NEWMAR CORPORATION WARRANTY DEPARTMENT

DESCRIPTION OF PROBLEM							
Poor ride quality on All Star ME chassis equipped with Airtek front suspension.							
RECOMMENDED SOLUTION							
Replacement of front shock absorbers. Spartan procedure for replacement of the shocks is attached; be sure to READ THE ATTACHED PROCEDURE PRIOR TO BEGINNING REPAIRS. Contact Spartan Motors regarding any questions you may have on this Technical Service Bulletin.

TSB07-250-002

- SUBJECT:** Front Suspension – Shock(s)
- APPLIES TO:** Certain 2008 Newmar Allstars produced with an Airtek front suspension having a VDM between December 8, 2006 and November 1, 2007.
- CONDITION:** The shocks on the Airtek front suspension produce an unacceptable ride of the coach.

Figure 1-1:

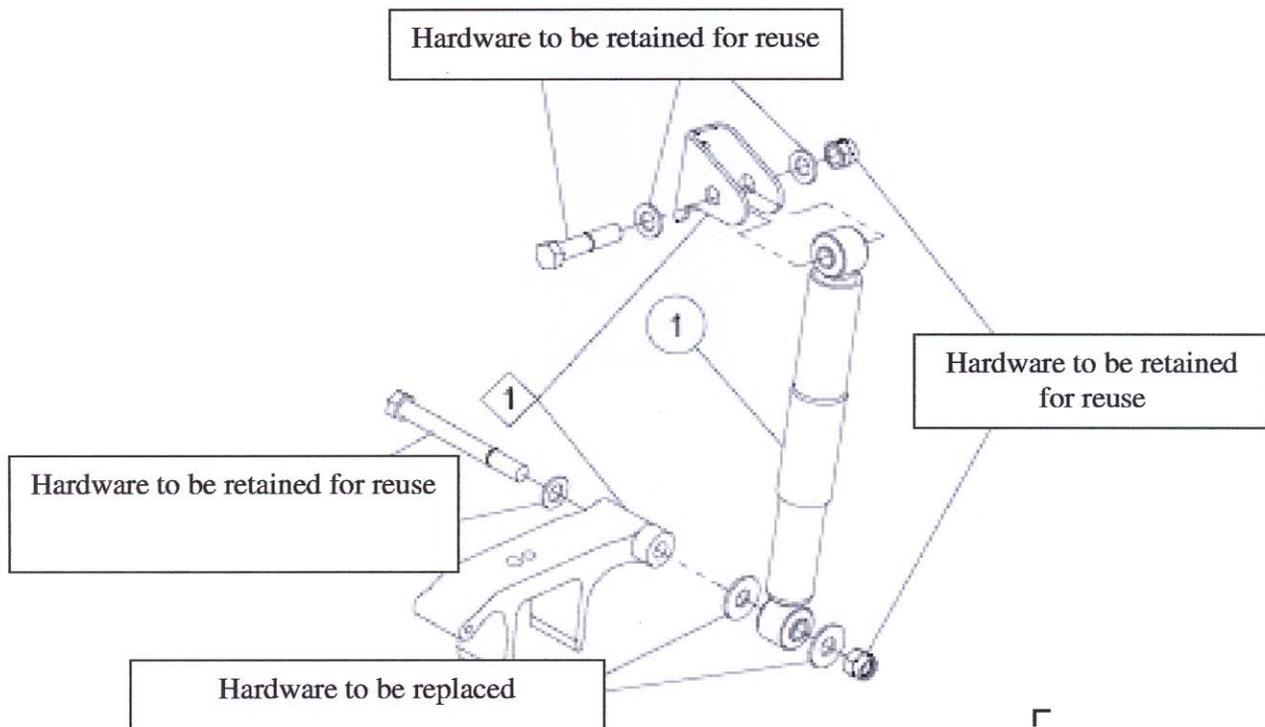
5. Remove the upper mounting fastener from the shock absorber. Retain hardware for reuse.
6. Discard shock absorber.
7. Remove new shock absorber from service kit. Install upper end of shock absorber per the illustration provided in Figure 1-1, utilizing appropriate hardware. Tighten fastener but do not tighten to final torque.

9. Install 2 new flat washers per the illustration, provided in the service kit. One on each side of the shock absorber eye must be installed.
10. Tighten the lower mounting hardware but do not tighten to final torque.

11. After shock absorber is installed and secured, using an appropriate tool, torque both the upper and lower shock mounting fasteners to 240 lbs ft. from the nut side.
